ATTACHMENT 1

COMMENTS AND RESPONSES

Text Changes to the Initial Study

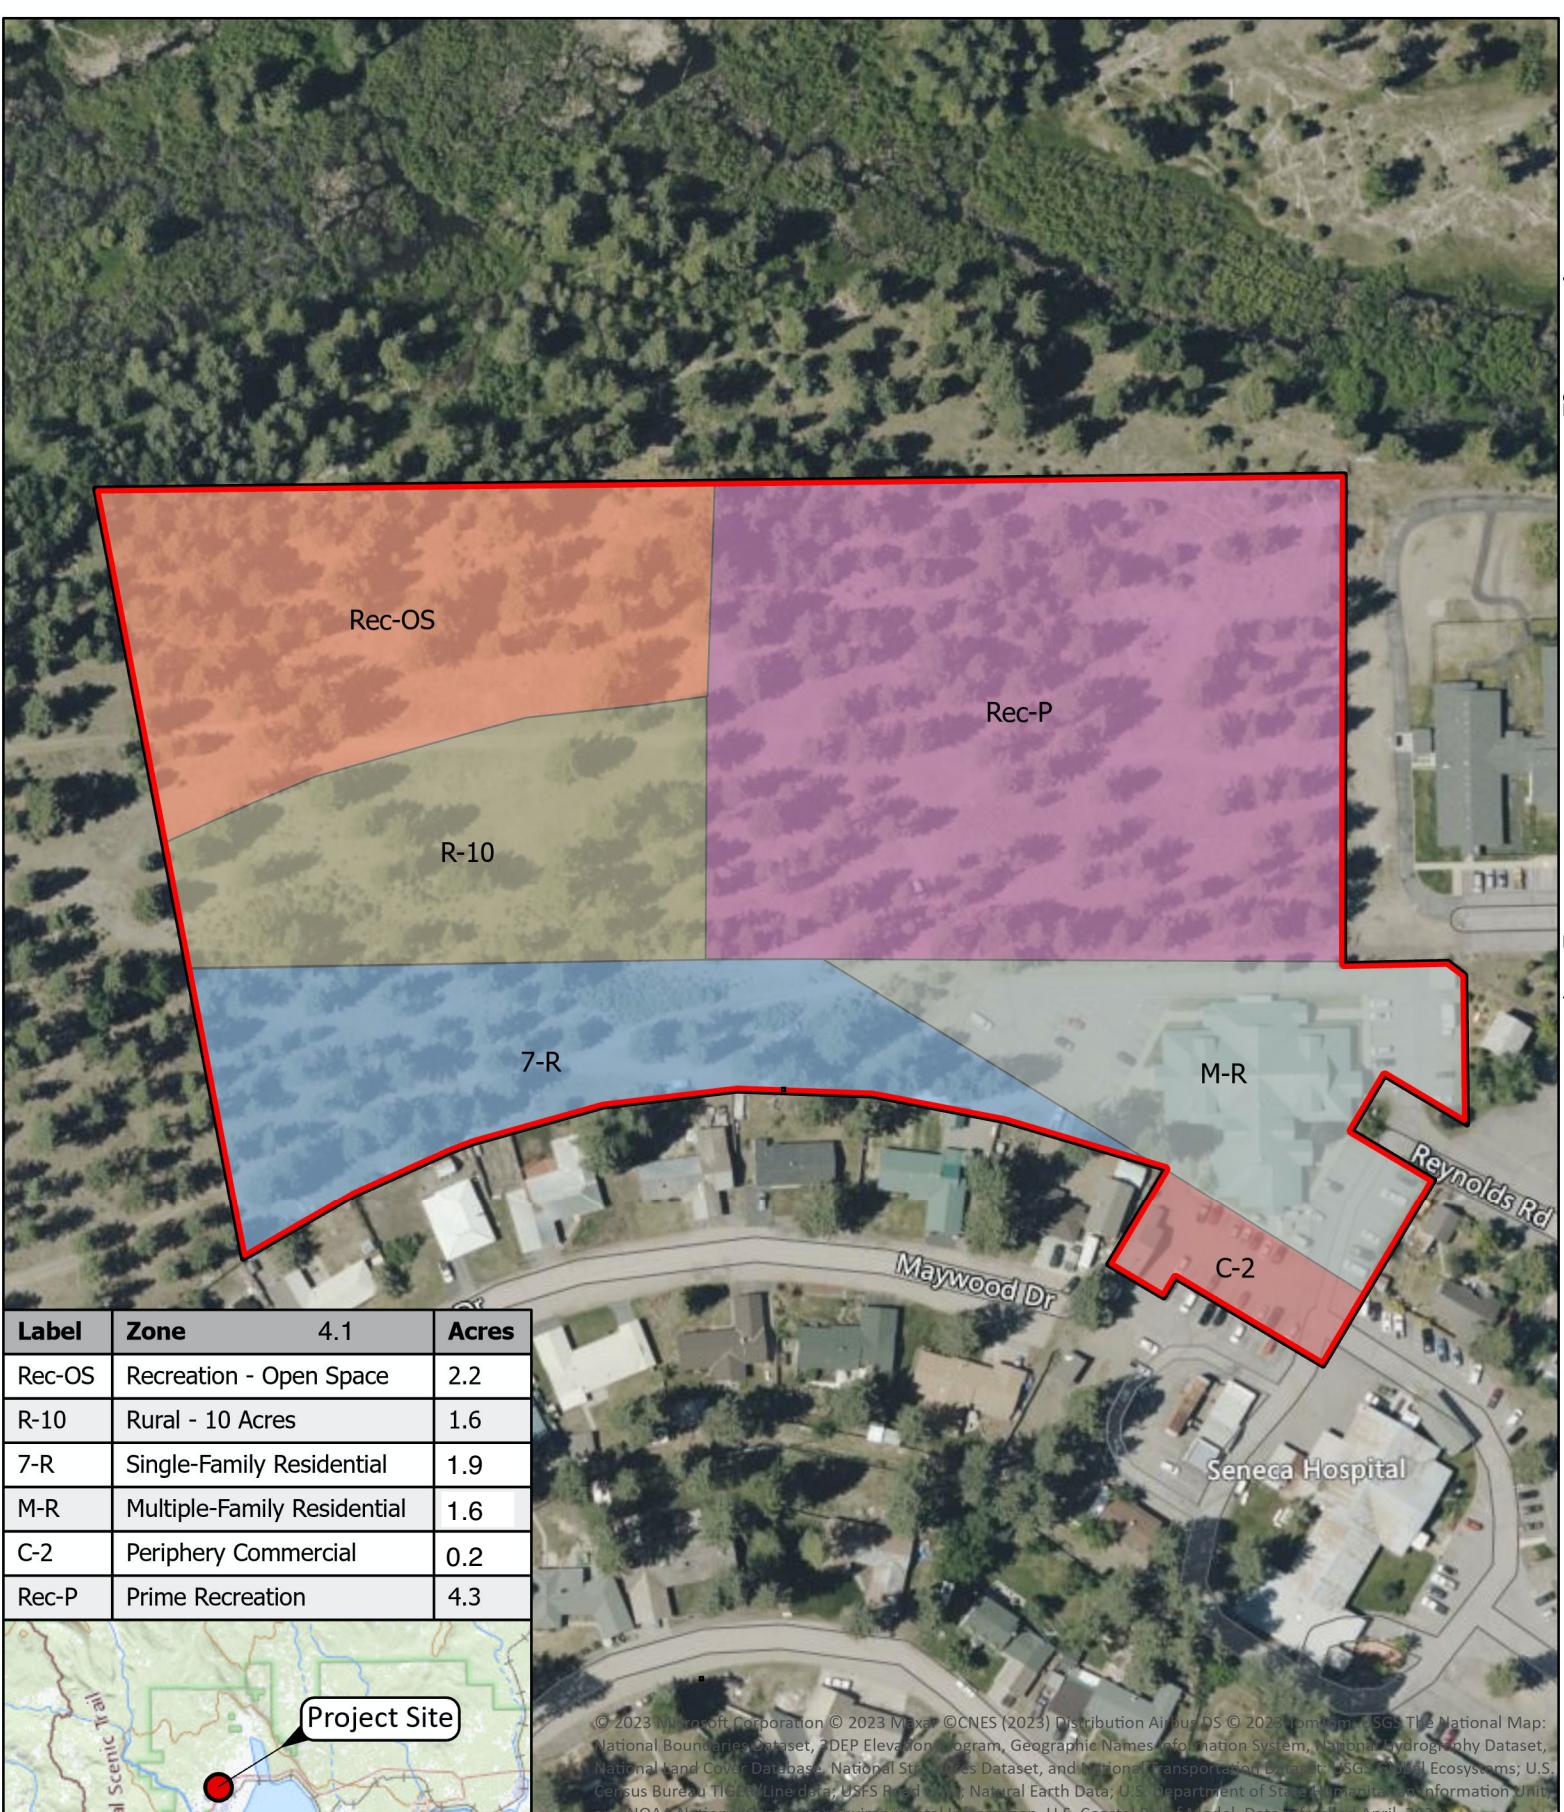
Exhibit C1 (Existing Zoning) is replaced with the following exhibit, which reflects the revisions to Page 62, Table 3 listed above. Exhibit C2 is replaced with the following exhibit in order to maintain consistent format between the two exhibits.
